Adequacy Review #1 / TR-05 / Lyons Quarry / M-1977-141

The purpose of this document is to support the request to the Colorado Division of Reclamation Mining and Safety (DRMS) for a Technical Revision (TR) to the 112c Reclamation Permit Operations for Lyons Quarry (File number M-1977-141). The objectives of this document are to provide a narrative and updated Exhibits that explain the requested revisions to the approved Reclamation Plan based on changes in the mining operations at Lyons Quarry. Revised Exhibits include the following:

CIVIL SITE ACCESS & STAGING AREAS

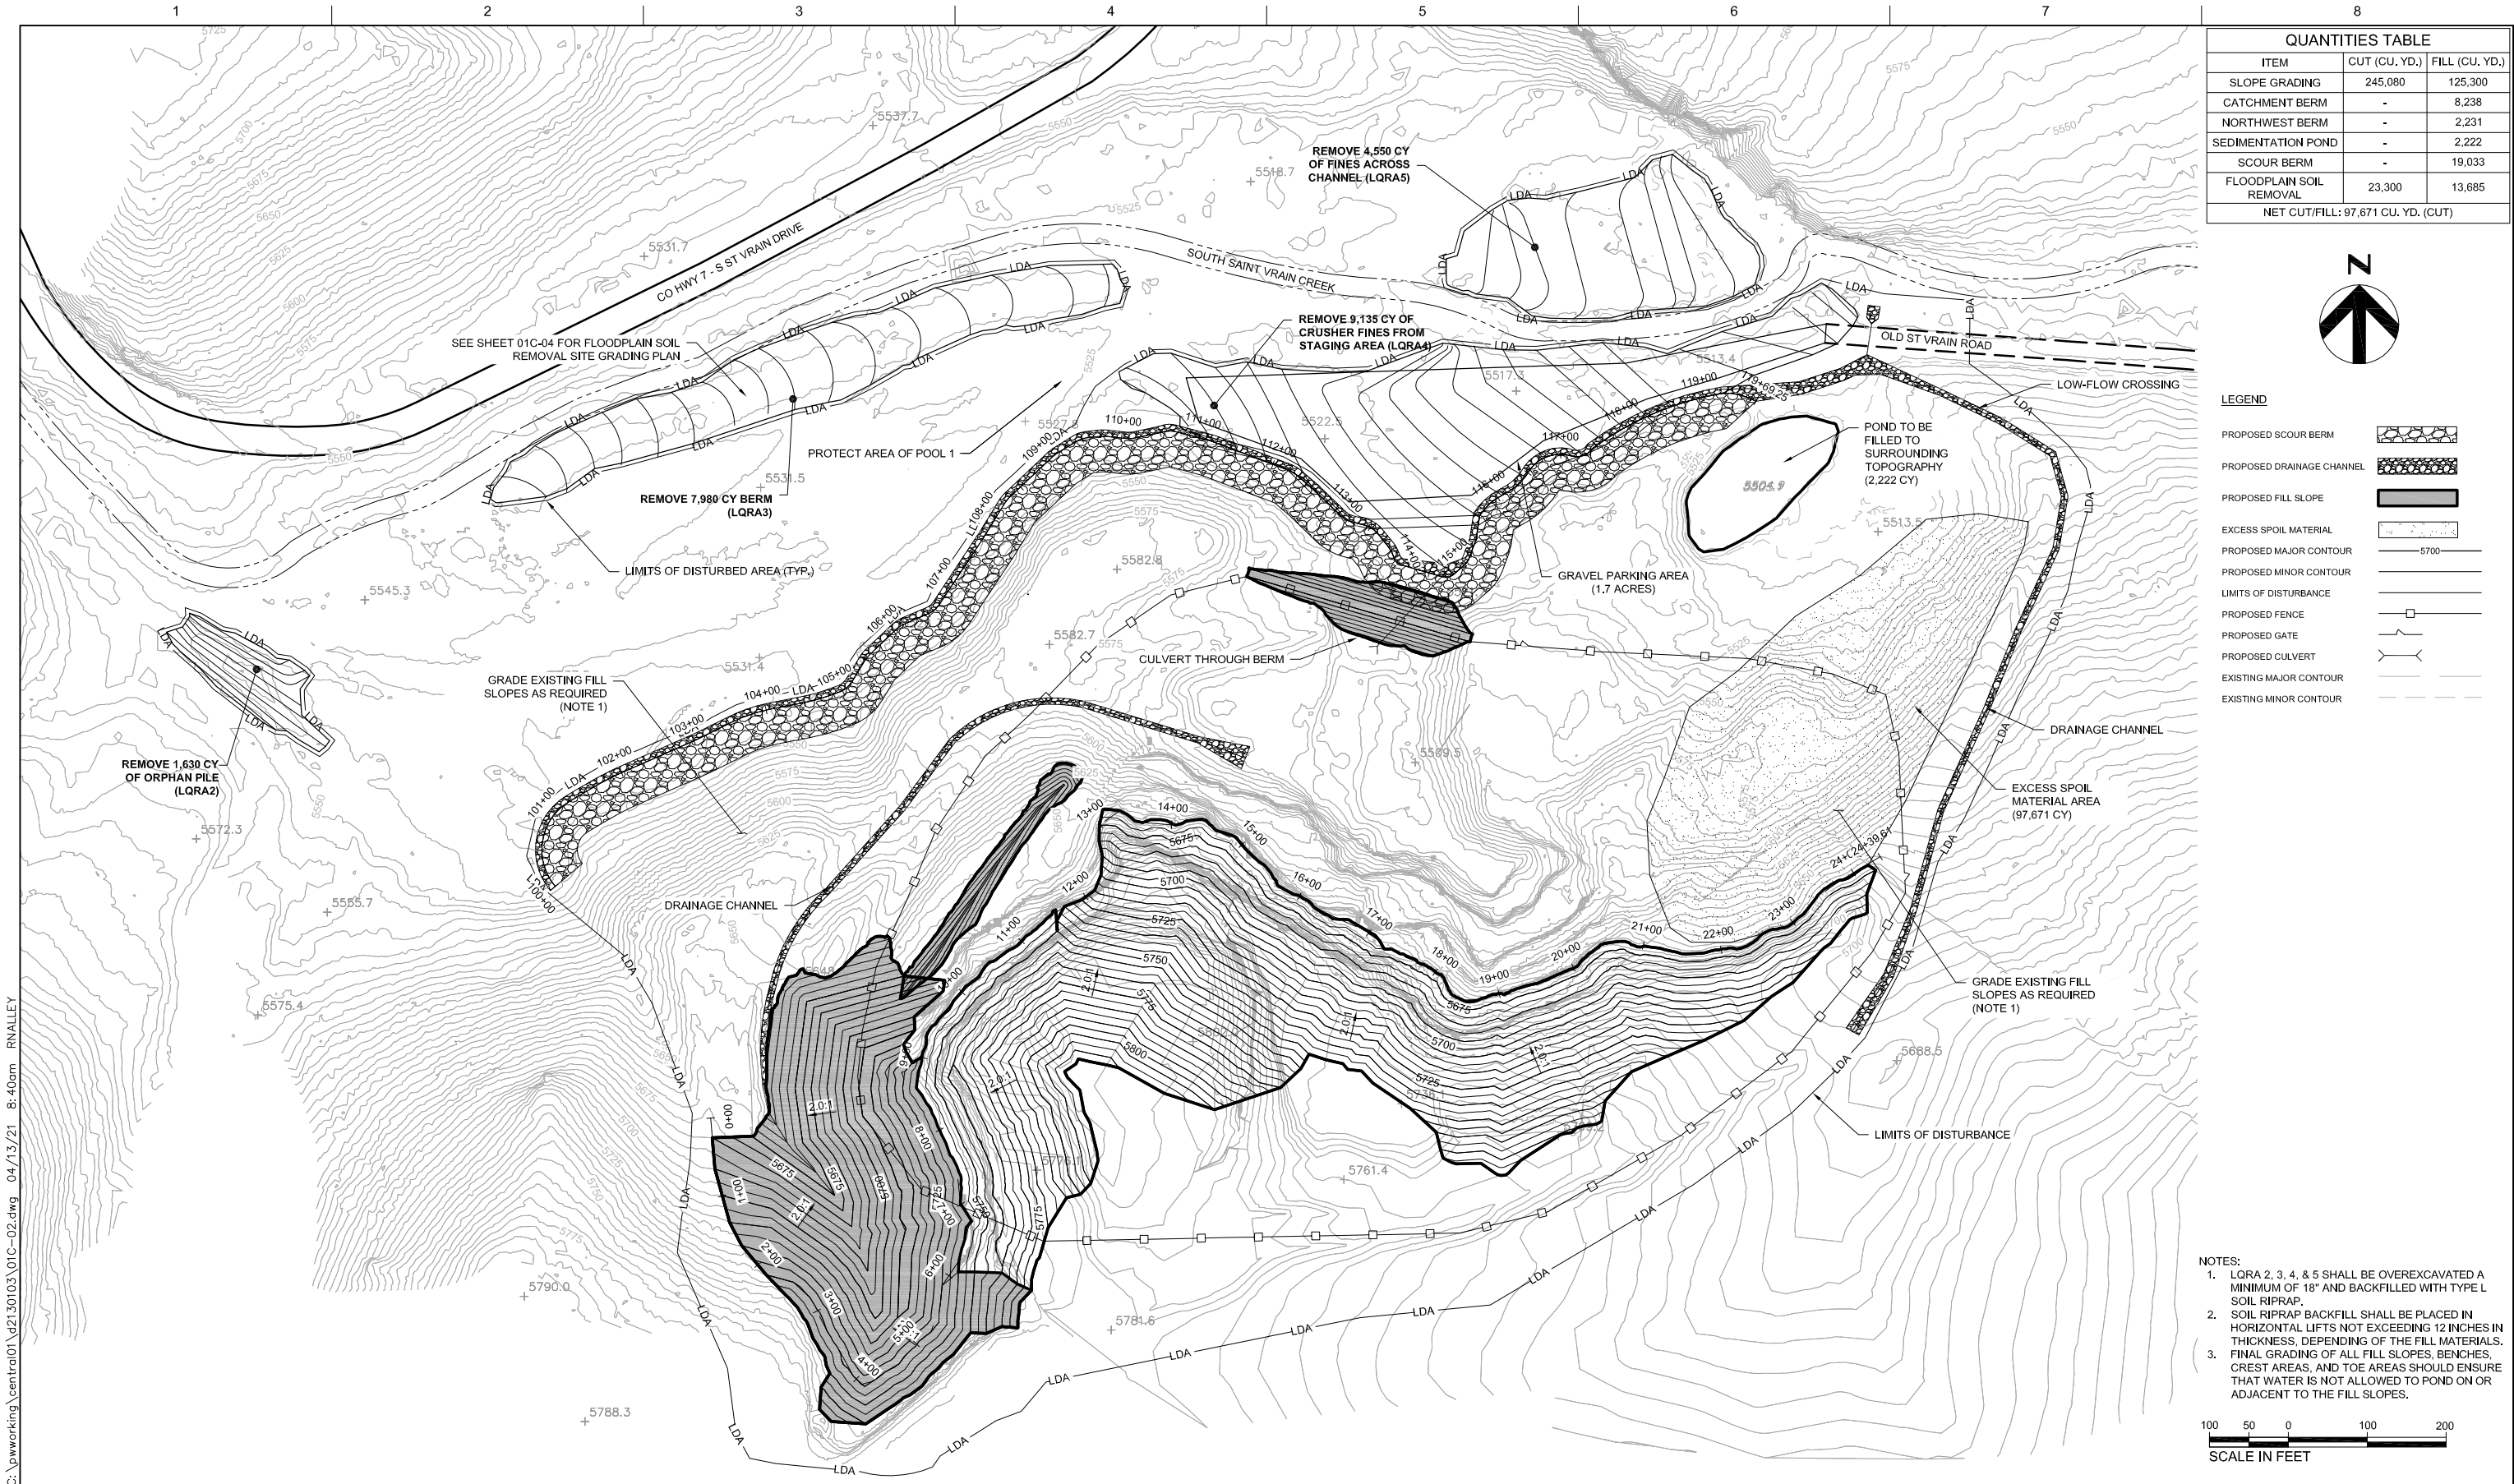
6	On Page 13, under Section 3.6, the text mentions leaving a parking area for future public use. If the operator proposes leaving a parking area for reclamation, please provide more details on this parking area, including its approximate size and whether it will be paved or graveled for reclamation. Please be sure this parking area is shown on the revised reclamation plan map, and that costs to pave or gravel the area are included in the bond estimate.	Propose to use reclaimed crusher fines for parking area topping. This area will be delineated and described in the narrative.
7	On Page 13, under Section 3.7, the text states "Available onsite topsoil sources will be utilized where needed but any additional topsoil and fine sediment material, including those from the floodplain area, would be assessed for utilizing offsite at municipal or State projects". Please commit to not removing any material from the site that could potentially be used for reclamation of the affected lands until all reclamation earthwork has been completed.	Confirmation that organic material will only be considered for export after all reclamation earthwork is complete, will be added.

Aggregate proposes to leave the current parking area, located within the floodplain reclamation area LQRA 4 (Attachment B, Sheet 01C-04), in place for future public recreation use. This area is currently covered with a layer of crusher fines and Aggregate will use reclaimed crusher fines to develop a parking area approximately 1.7 acres as shown on Sheet 01C-01 in the design drawings (Attachment H).
